Addendum No. 03

PORTERVILLE COLLEGE FINE ARTS DARK ROOM

PBK PROJECT NO.: S2102800AR
DSA FILE NO.: 15-C1
DSA APPLICATION NO.: 02-121796

STATUS
ELECTRICAL DEMO PLAN

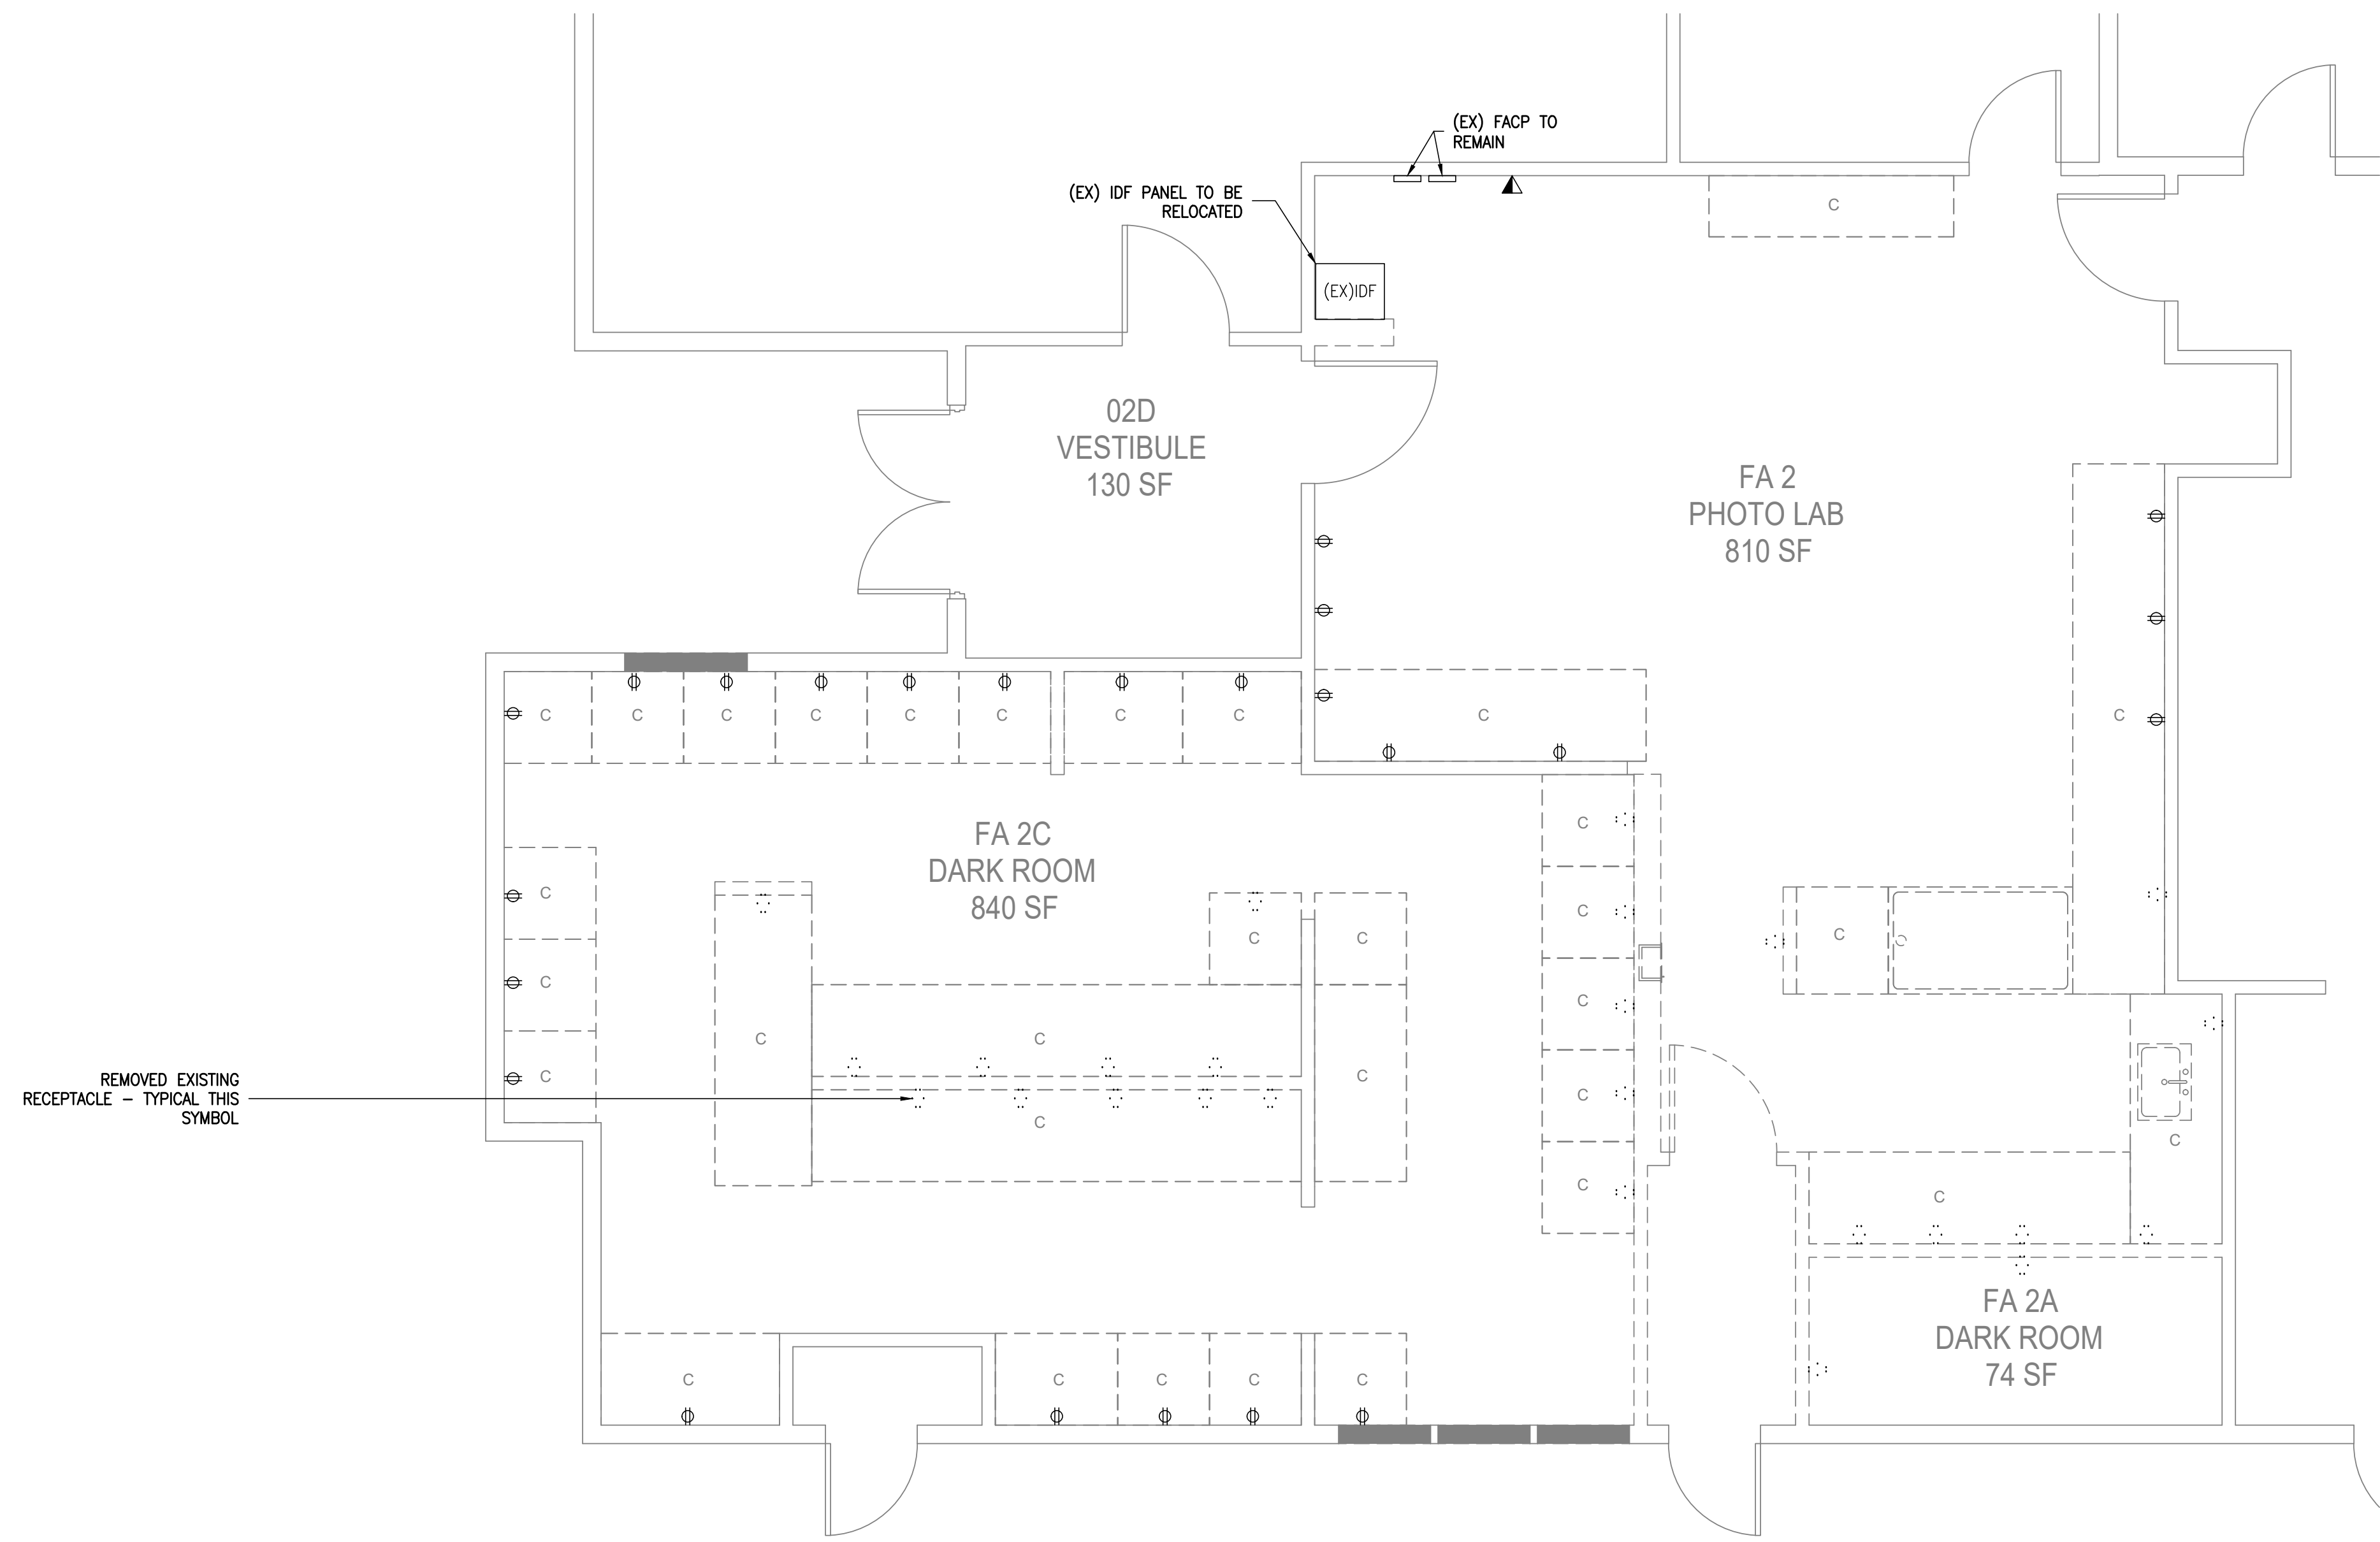
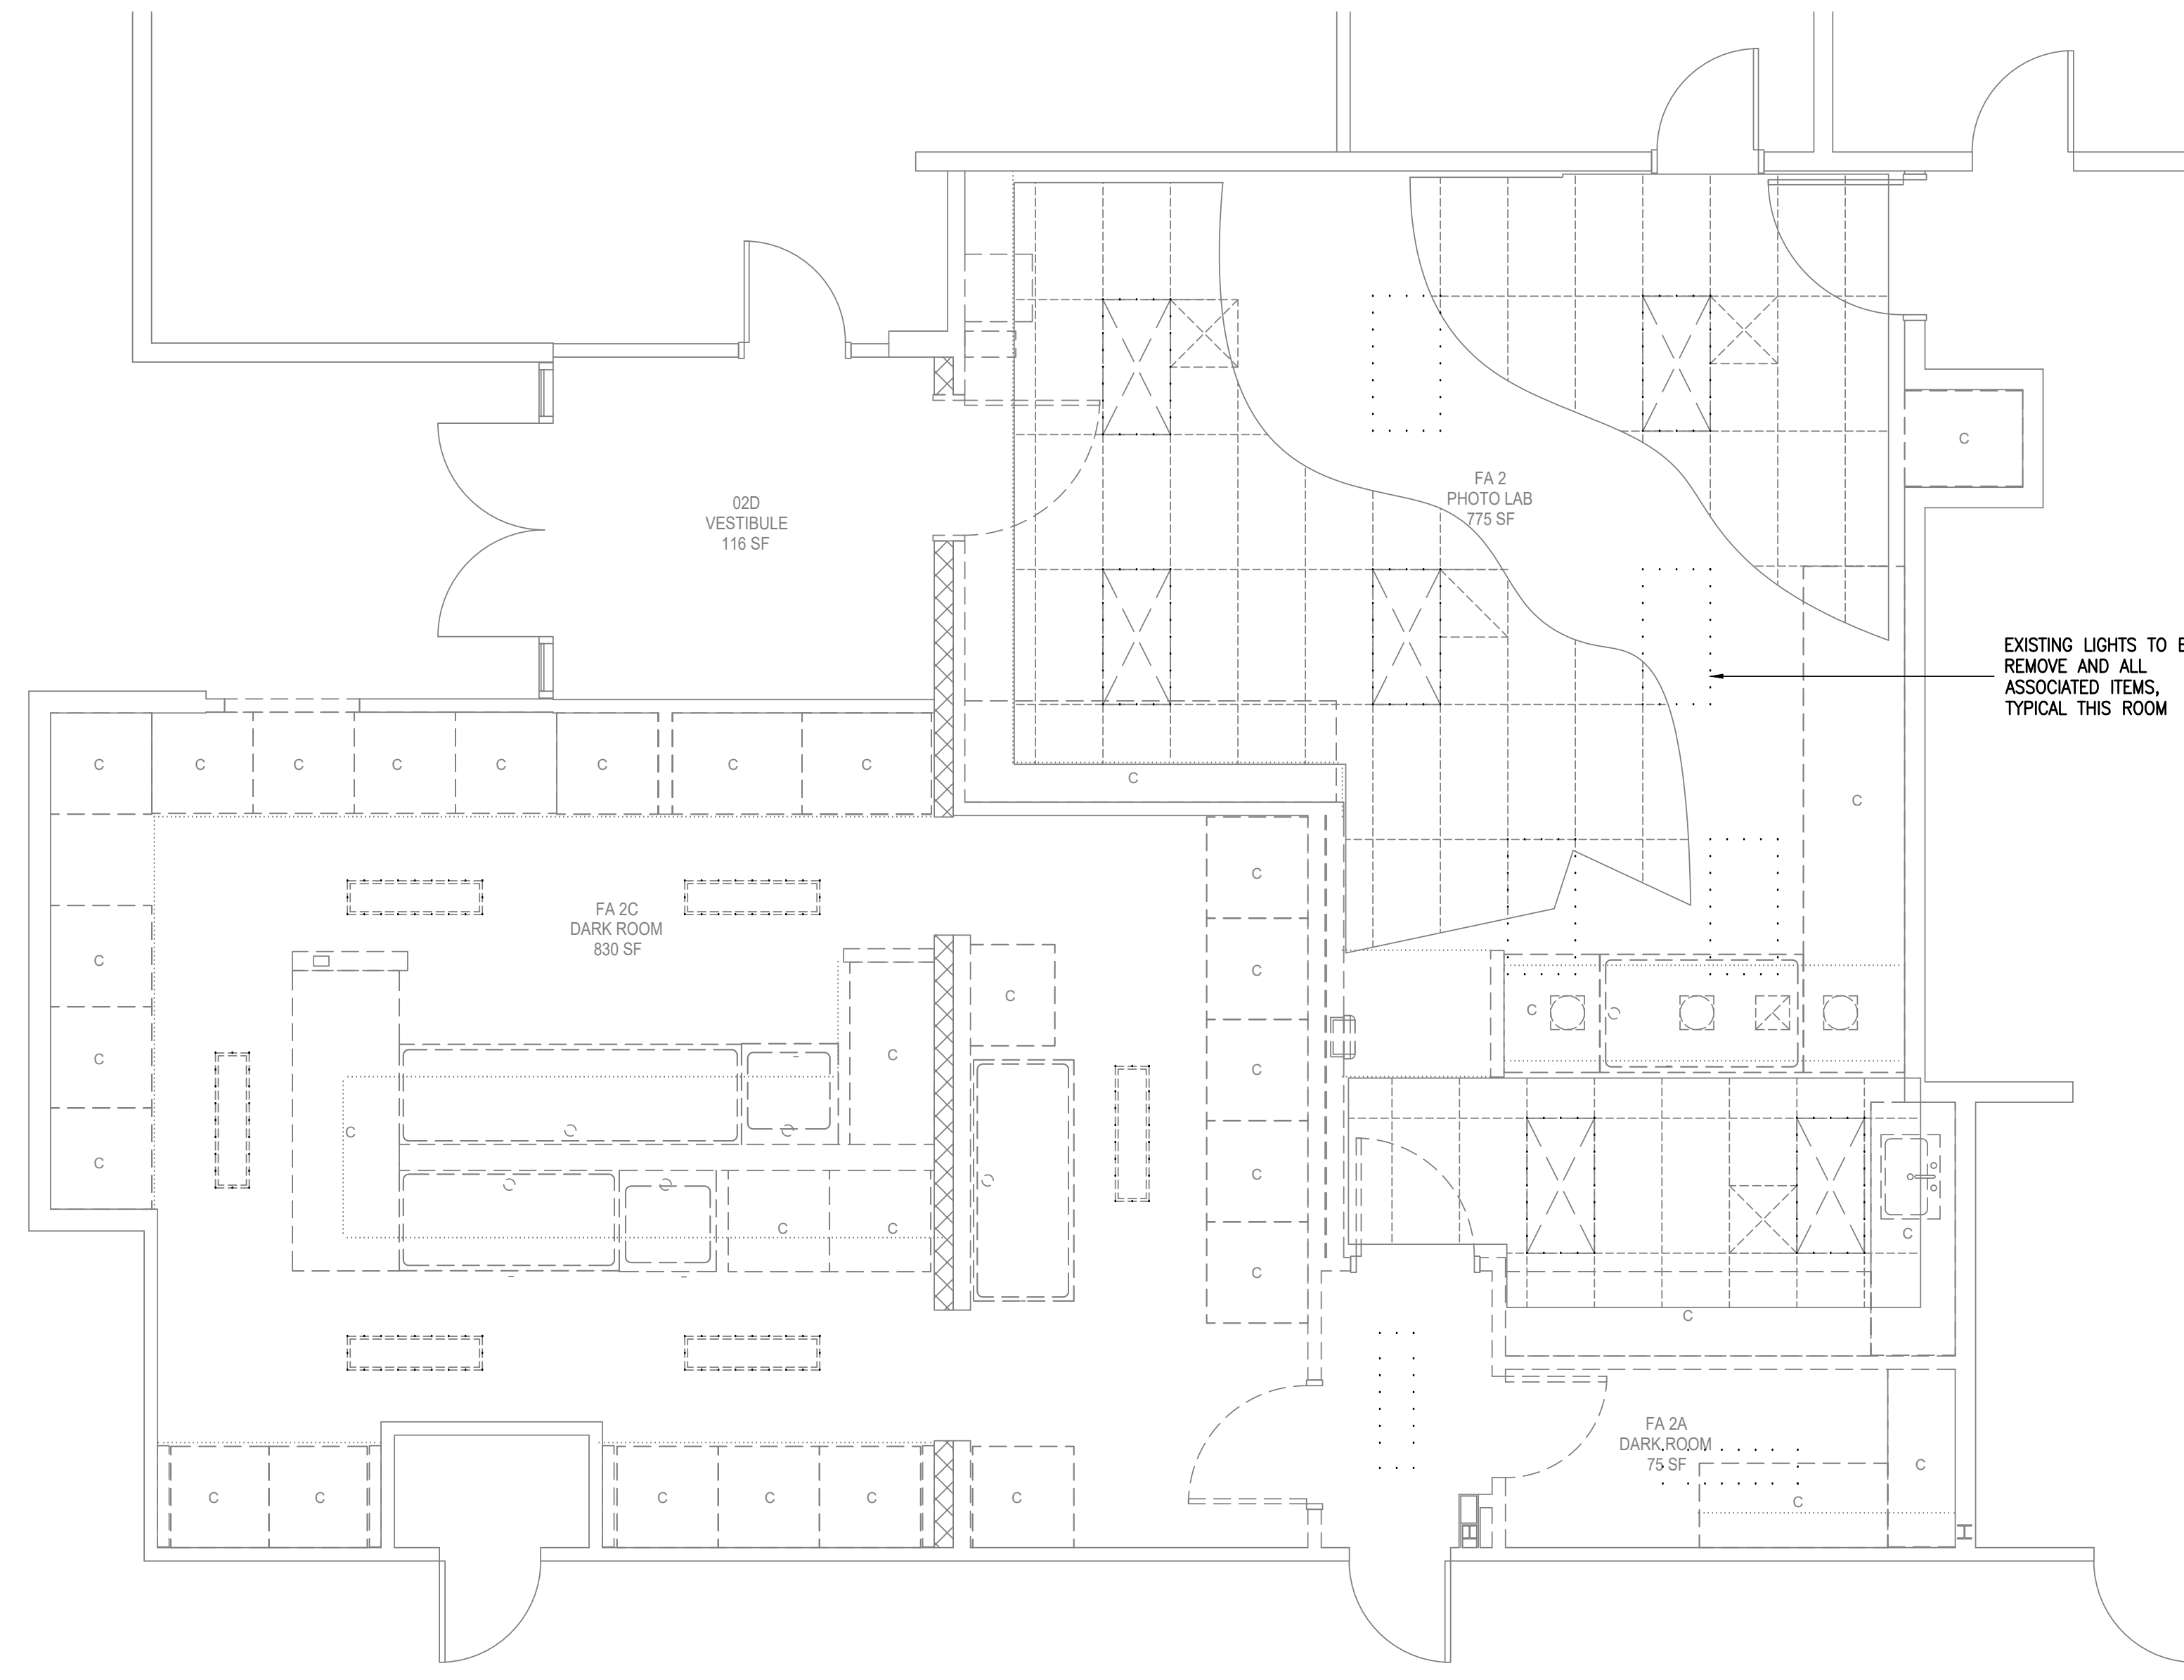
AD3-01 SHEET E2.0 – Electrical Demo Plan
Contractor shall replace existing sheet E2.0 Electrical Demo Plan with the revised sheet E2.0 Electrical Demo Plan attached herein.
